## Development Services Staff Report

| <b>File Number</b>              | PL2020-134   |
| <b>File Name</b>                | PRELIMINARY DEVELOPMENT PLAN – Lee's Summit R-7 Middle School #4 |

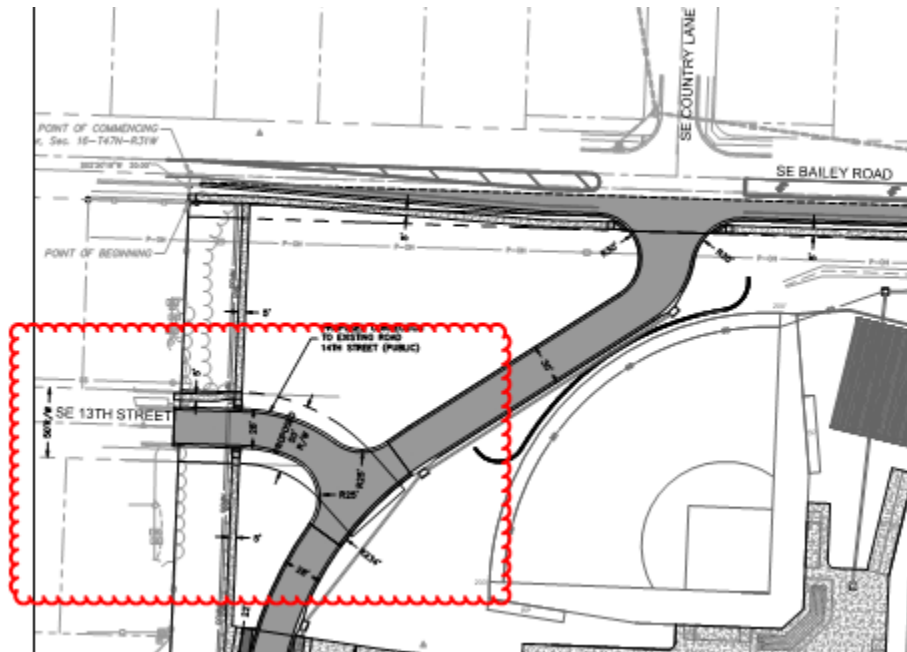
**Tree Size.** Modification requested.

- Required – Deciduous trees shall be a minimum 3" caliper in size at the time of planting.
- Proposed – 2" caliper deciduous ornamental trees
- Recommended – The UDO's minimum 3" caliper size requirement applies to deciduous trees as a whole. The minimum size requirement applies equally to shade trees as it does to ornamental trees. Based on feedback the City has received from the development community, typical landscape nursery stock of ornamental trees is 2" caliper in size. The City has also received feedback from landscape professionals that the survivability of 2" caliper ornamental trees is significantly greater than that of larger ornamental trees. Given this information, Staff supports the request to allow 2" caliper deciduous ornamental trees.

1. A modification shall be granted to the minimum 3” deciduous tree caliper size, to allow 2” caliper ornamental trees.
2. Two monument signs with an overall height of 8’-10”, a sign face area of 40 sq. ft. and a sign structure area of 77 sq. ft. shall be allowed along SE Bailey Rd as depicted on the preliminary development plan.

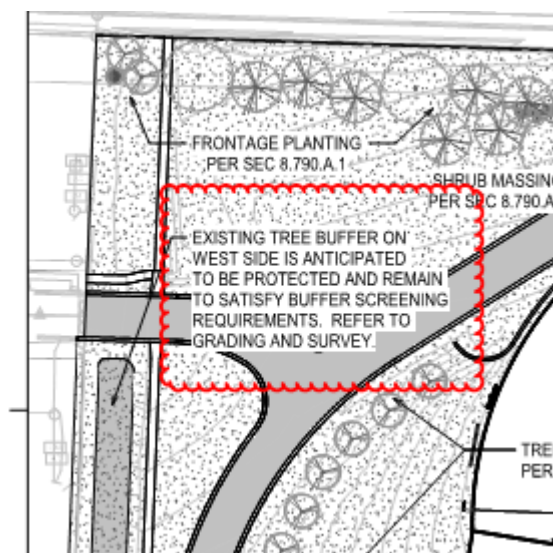
- **Can the existing treeline along the west project boundary adjacent to the Newberry subdivision be retained?**

Current plans call for the protection and retention of the existing treeline to serve as a buffer between the abutting developments.
